SUBJECT: Morris Municipal Airport

Illinois Project No. C09-4089 SBG Project No. 3-17-0071-B16

Contract No. MR021

Addendum A

RUNWAY EXIT AND TAXIWAY GUIDANCE SIGN DETAIL

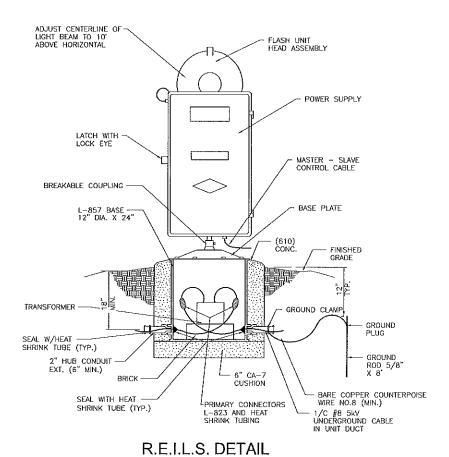
Exhibit C of the Special Provisions contains a Runway Exit and Taxiway Guidance Sign Detail which contains dimensions and a typical layout of the sign system.

Runway and Taxiway Guidance signs and panels shall be Type L-858, Size 1 and Style 3 to match existing signage.
